Re: TED-2007-331 – 24 Road City Market

Transportation Engineering Design Standards (TEDS) Exception Approval / Denial Form

Comment: Their exact configuration is existing in the Sam's parking lot and works well. They submitted a few examples of other municipal regulations their design meets. Both TEDS exceptions go hand in hand. #1 is for stall length and #2 is for aisle width: could have been one.

Section: 4.3.2.1 – Parking Stall and Aisle Design – Design table

PARKING DESIGN STANDARDS
CHART NO. 3

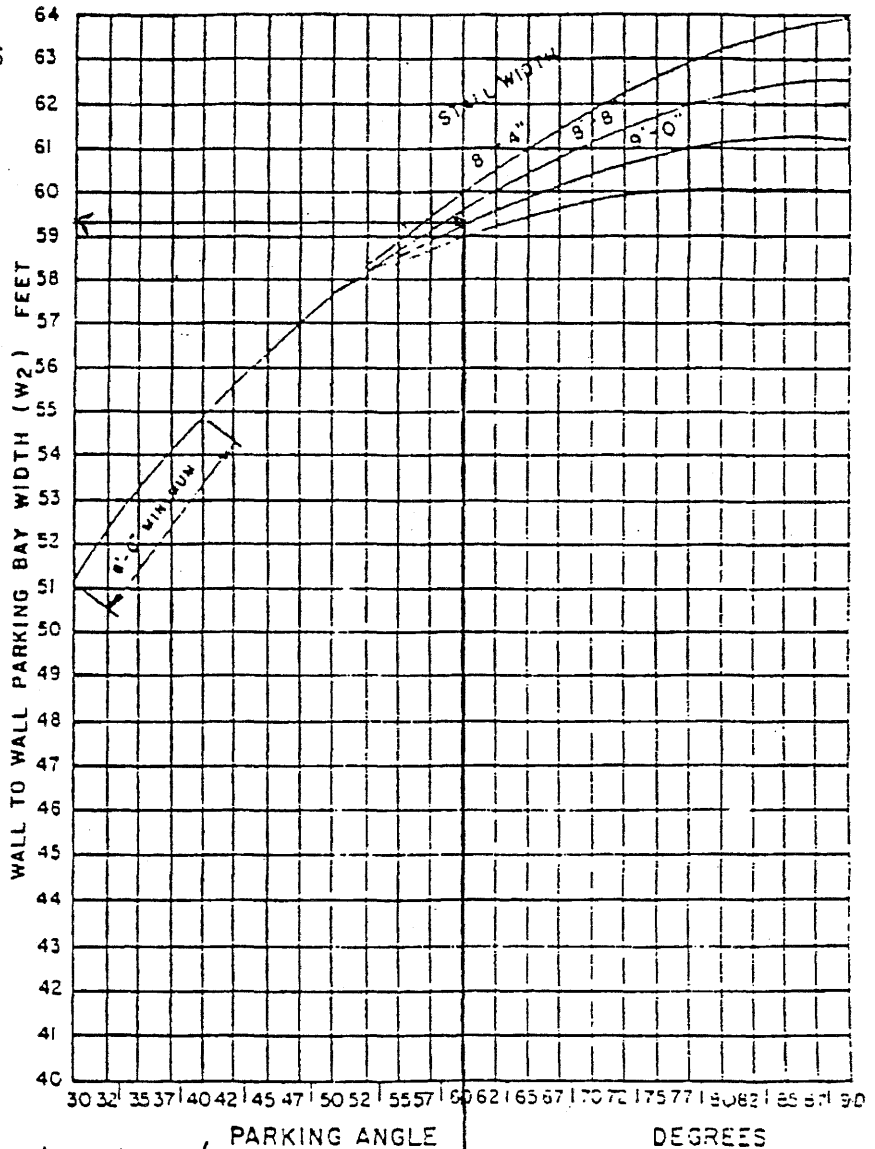
Grand Junction
City Market

$$= 18 + 24 + 18 = 60'$$

Meets Criteria

EXCEEDS OVER ALL by +0.6'

HORIZONTAL CONTROL PLAN

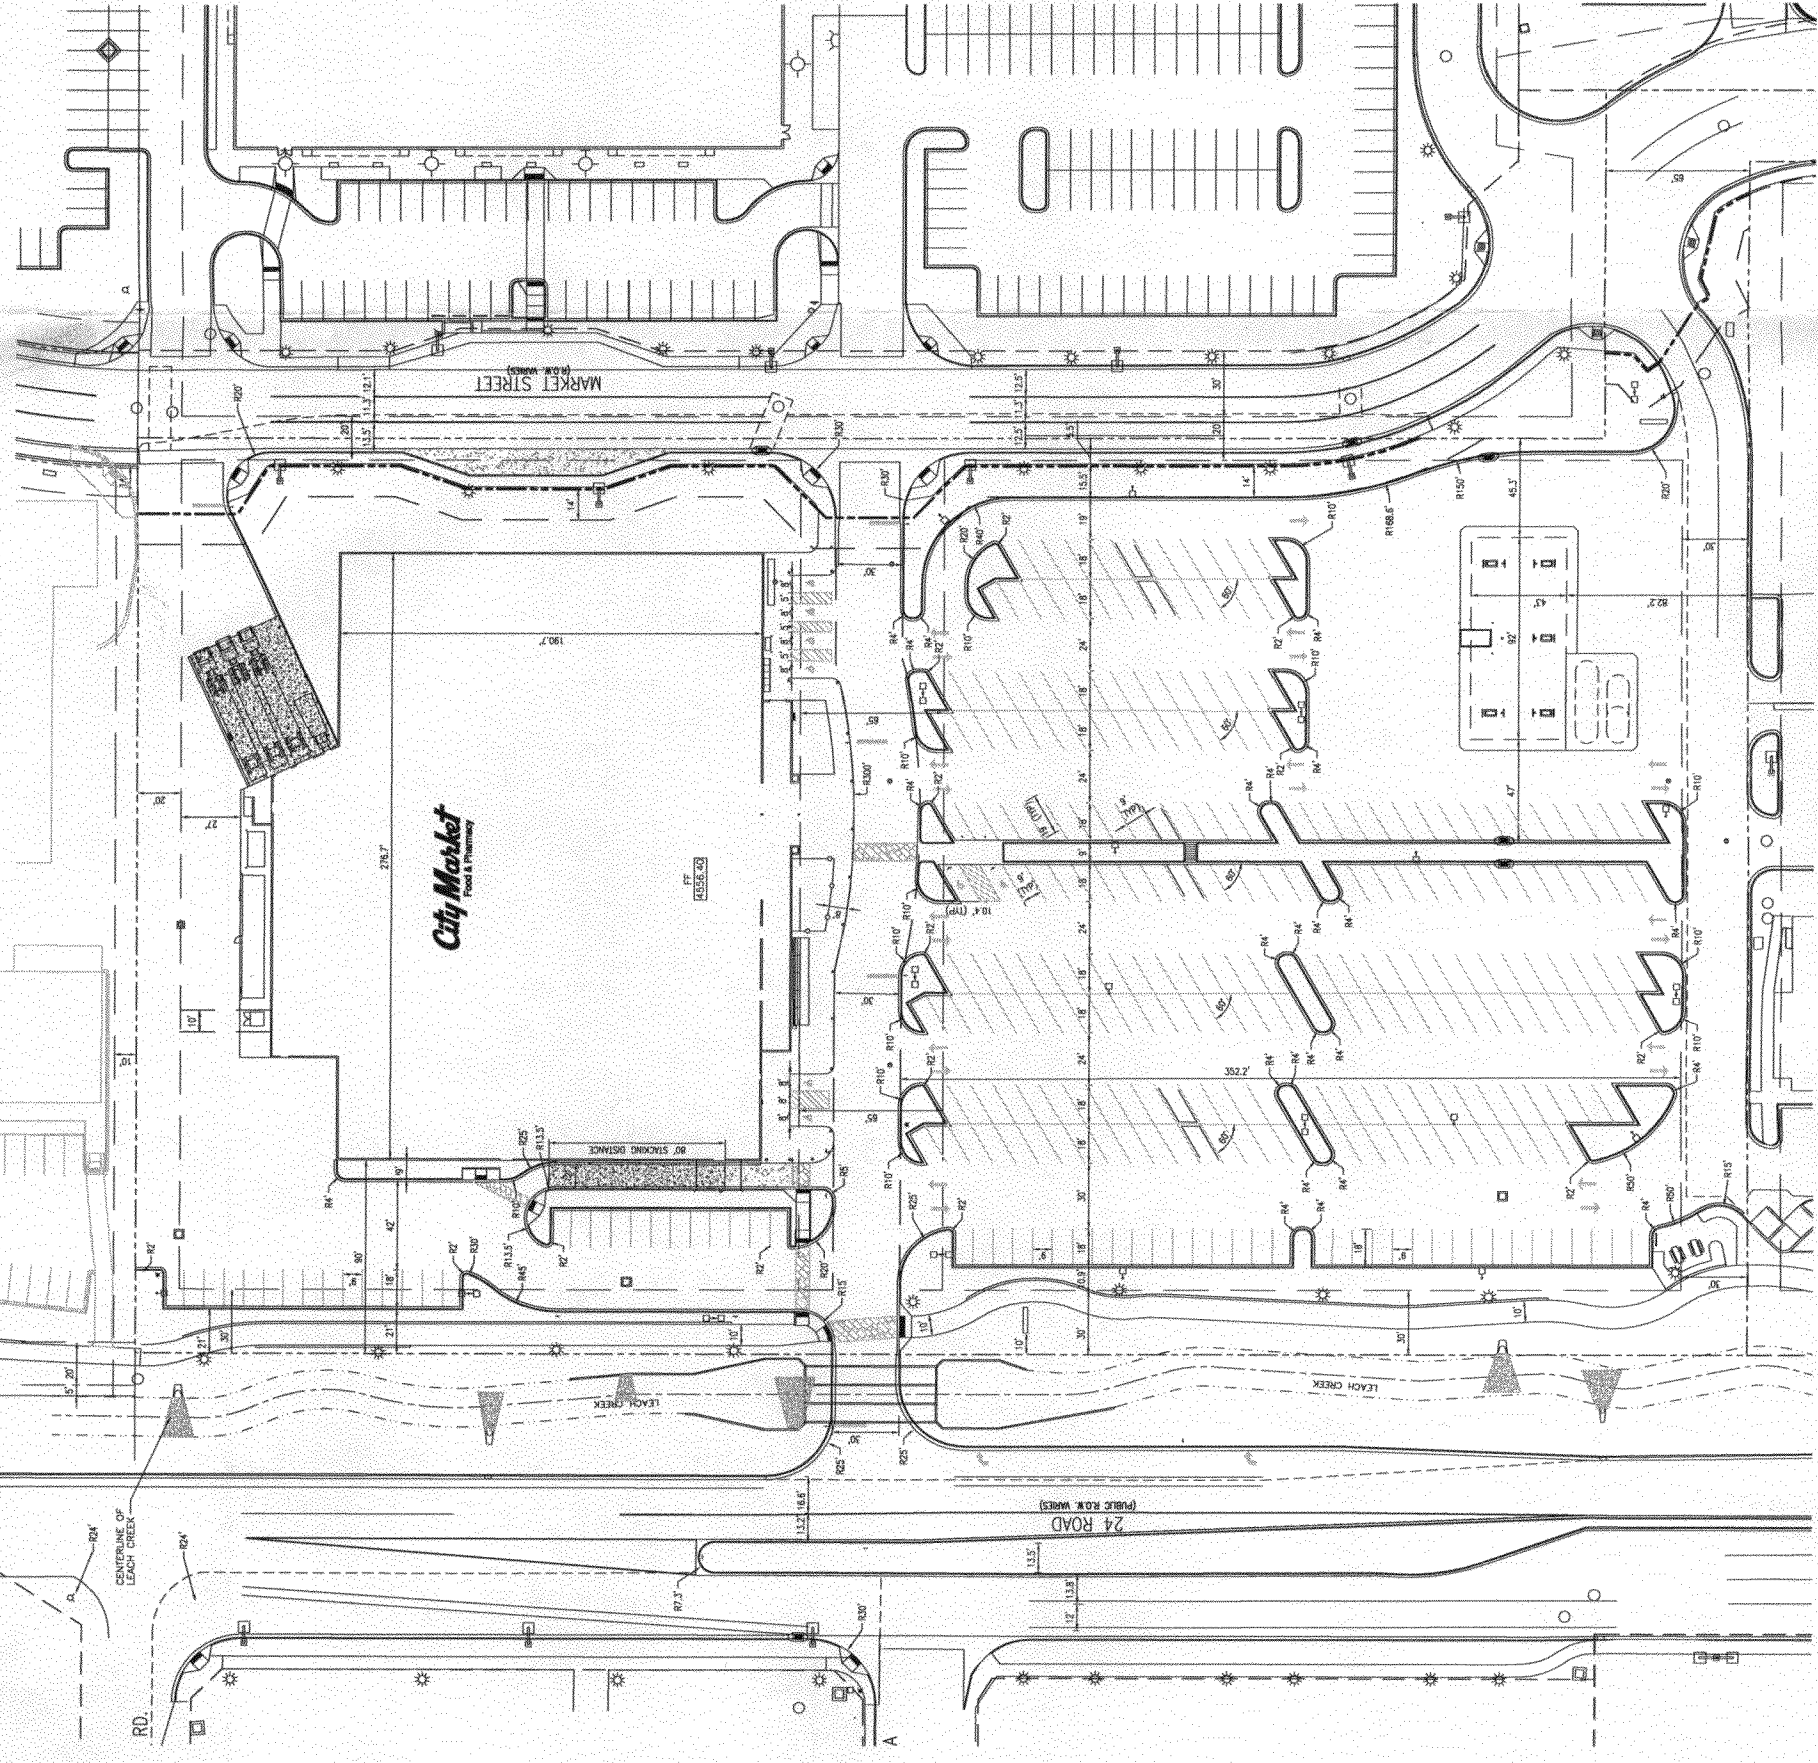
Request #1 - Revise parking stall lengths from 21' to 18'

Request #2 - Revised drive aisles from one way (16') to two way drive aisles (24' and 30')

Site is accessed by a proposed access drive to 24 Road, and existing private drive south of the site, and two access drives from the existing Market Place roadway. Proposed site design is for 2 way drive aisles (24') with 60° stalls, and 18' stalls lengths (perpendicular to the drive aisle).

See the attached horizontal control plan showing aisle and parking stall dimensions.

Approved as requested.
